DeKalb County Historic Preservation Commission

Staff Report

G. 1071 Oxford Road, Dan Hanlon. Construct a second-story addition and demolish a porte cochere and enclosed porch on a historic house. **1247715**.

PRELIMINARY SITE PLAN

PROPOSED
FIRST FLOOR PLAN
SCALE: 1/4" = 1'-0"

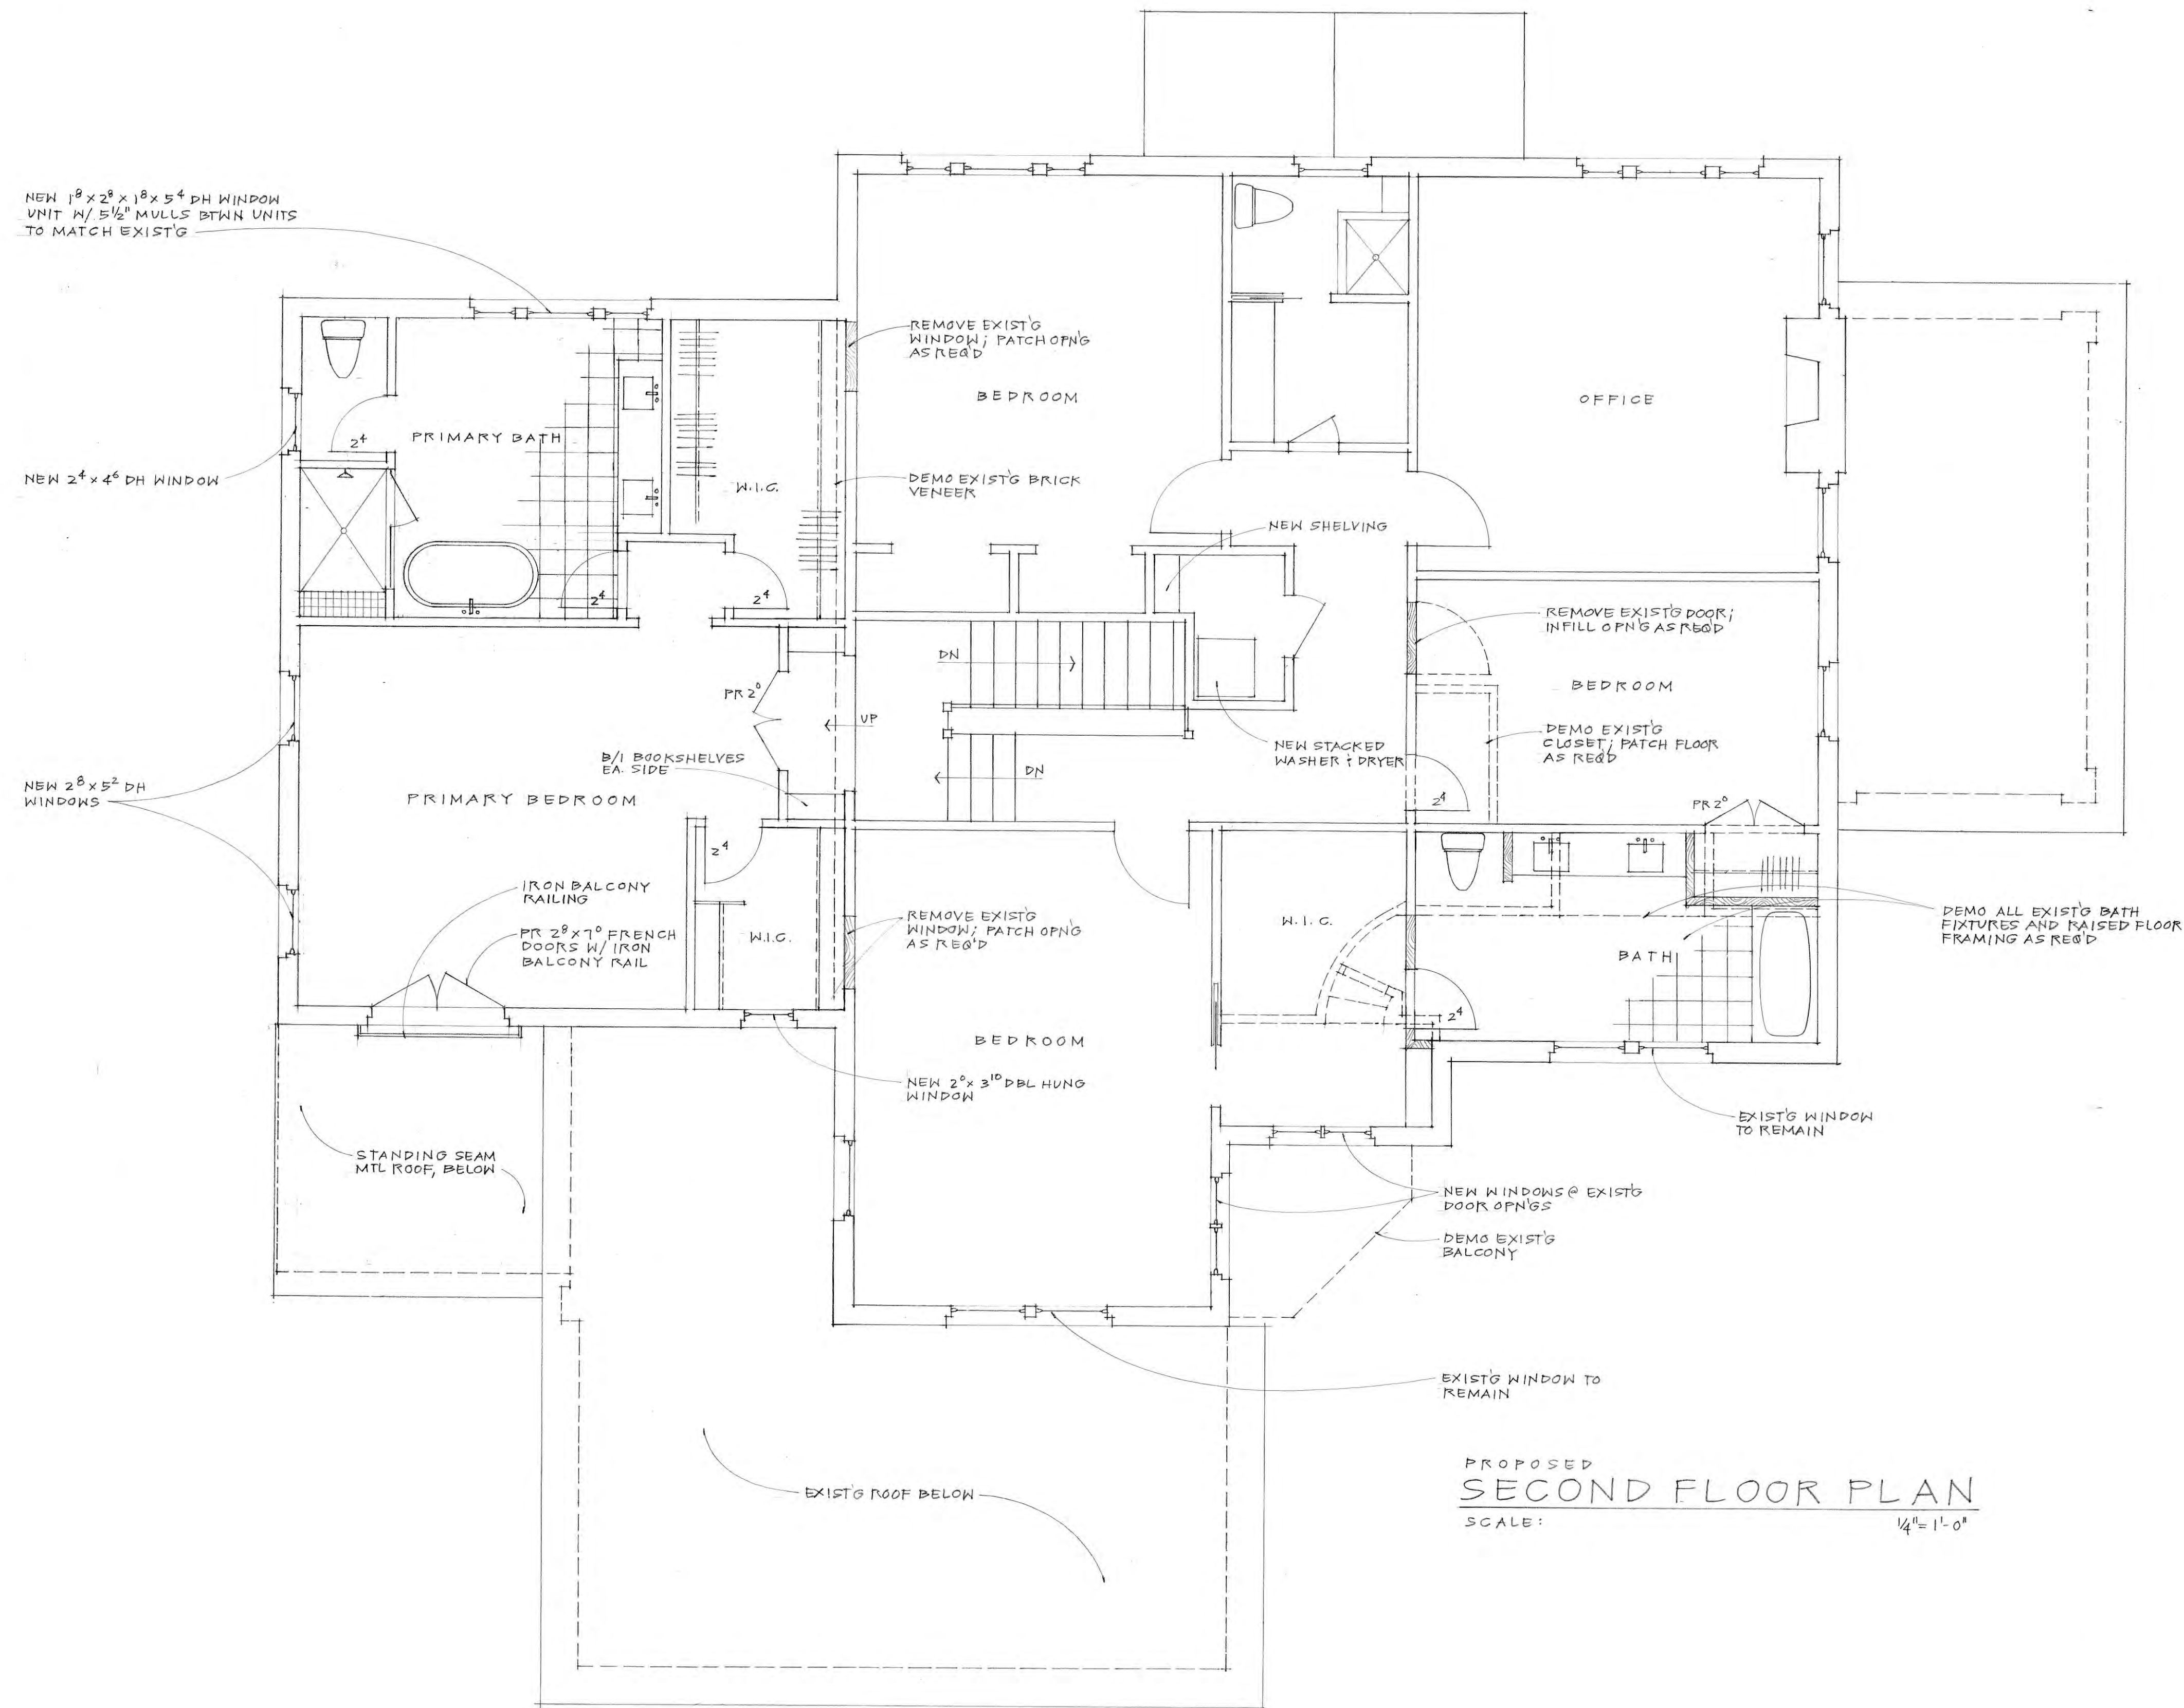
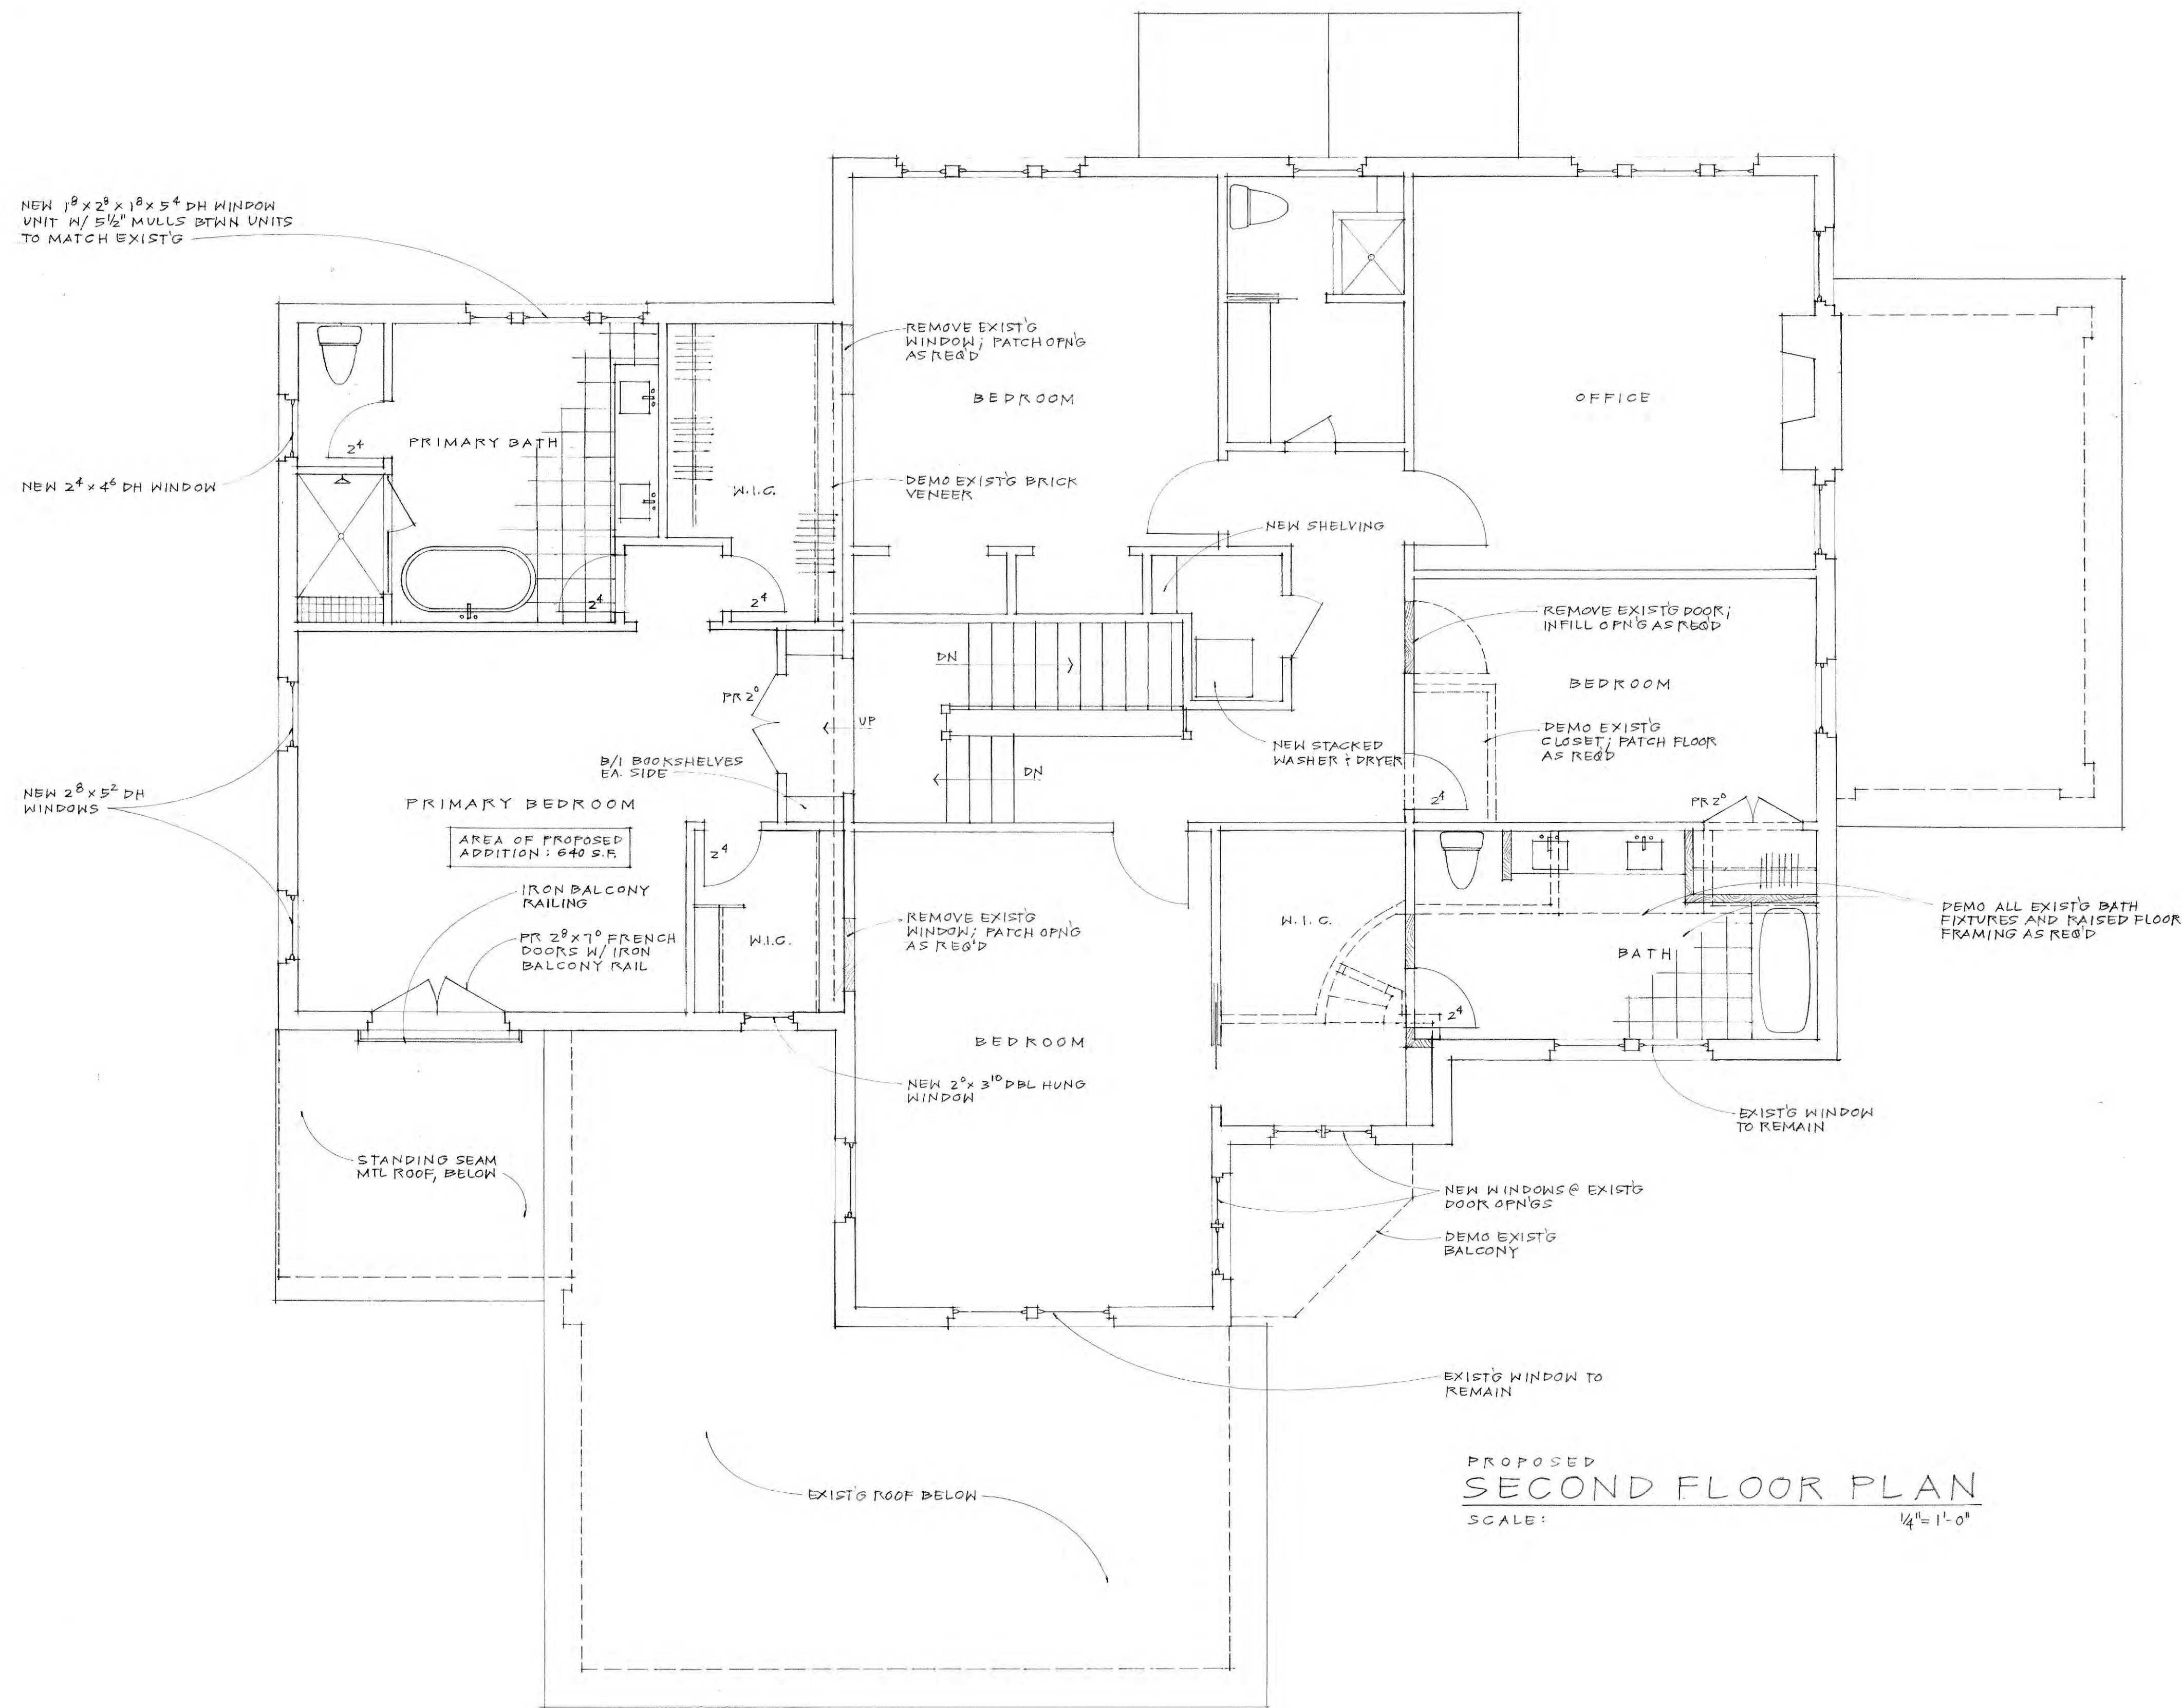
In addition to the site visit, the applicant also provided revised drawings and a revised site plan of the proposed addition as requested by staff. The revised documents confirms that the front façade of the proposed addition and front-facing garage will be set back 6 feet from the front façade of the historic house.

2. What is the proposed square-footage of the proposed addition? **The main level addition is approximately 738sf, and the second level is approximately 640sf.** Can you provide additional measurements, including the height of the proposed addition from grade to roof ridge **Approximately 28'6"** and its set back from the front façade of the historic house **Approximately 6'**?
